Planning Commission Study Session

SUBJECT: DR18-192, VAL VISTA & QUEEN CREEK, LOT 3

DR18-192, Val Vista & Queen Creek, Lot 3: Site plan, landscaping, grading and drainage, elevations, floor plans, lighting, and colors and materials for approximately 2.12 acres, generally located at the southeast corner of Val Vista Drive and Queen Creek Road, and zoned Shopping Center (SC) with a Planned Area Development (PAD) overlay.

PAD'A' SEC VAL VISTA DRIVE AND QUEEN CREEK ROAD GILBERT, ARIZONA

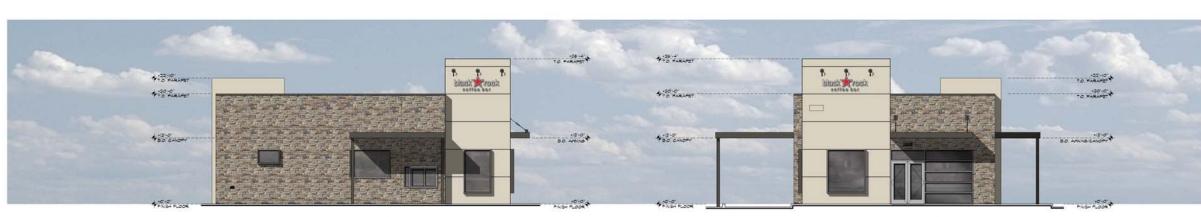
The colors and materials proposed are in compliance with the Site Development Guidelines for Val Vista and Queen Creek. Both Pad A and Shops are consistent with the colors and materials from the approved palette for the overall site. Pad A includes a more simplistic palette with the base of the building being stone veneer and accents consisting of painted stucco in Cargo Pants, a light neutral color, and metal in a medium bronze. The bronze of the approved color palette is somewhat grey toned. Staff suggests that the metal accents be Sherwin Williams Pennywise to warm the building and to be more in keeping with the very large care facility in the background.

Exterior light fixtures are proposed above the 14 ft. maximum height requirement to illuminate and accentuate proposed signage on Pad A. Wall-, soffit- mount, and similar exterior building light fixtures in excess of 14 feet above grade may be approved by the Design Review Board. Exterior building lighting of signage is not prohibited by Code, but is not typically used in Gilbert commercial properties. Additional findings of facts are required for this type of lighting to receive approval. Approval would be for the lighting only, the proposed signage is for reference only and will require a separate approval. All site lighting will be required to comply with Town codes and the Site Development Guidelines for Val Vista and Queen Creek.

SHOPS 'A'
SEC VAL VISTA DRIVE AND QUEEN CREEK ROAD
GILBERT, ARIZONA

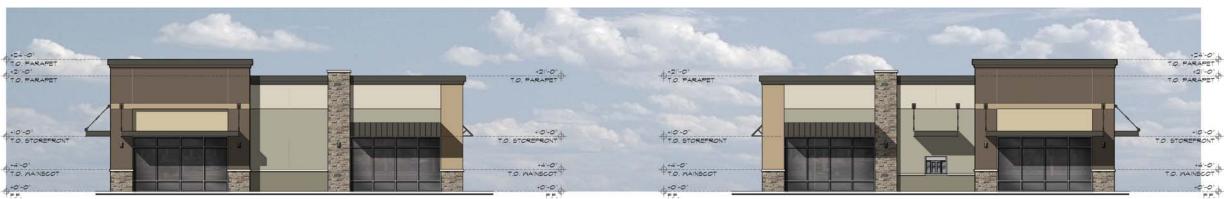
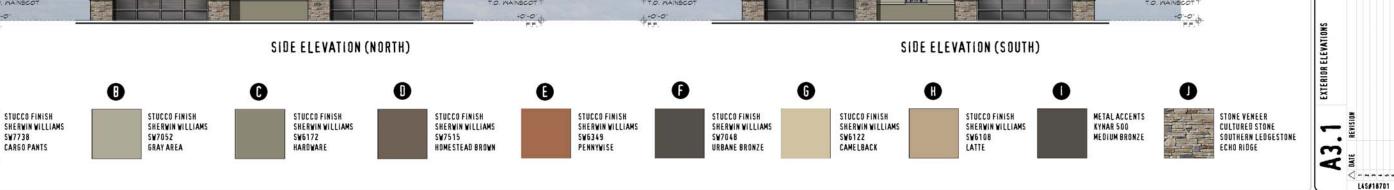
Staff is requesting input specifically on the west elevation facing Val Vista Drive. Staff suggests consideration of using Pennywise to the right and left of the central massing above the wainscot to add some additional brightness and interest.

Shops A, has a more diverse color palette proposed with painted stucco as the primary material and stone veneer and metal in medium bronze as accent materials. Staff suggests the possible use of the red tile roofing on the angled awnings instead of the metal. The tile would tie the building to the care facility and soften the architecture.

- 1. Elevations- Specifically the west elevation of Shops A, which faces Val Vista Drive.
- 2. Consideration of adding some additional warmer colors and textures to link the project to the existing building on site.
- 3. Lighting- Allowing exterior lighting fixtures above the 14 ft. maximum height requirement to illuminate proposed signage on Pad A.
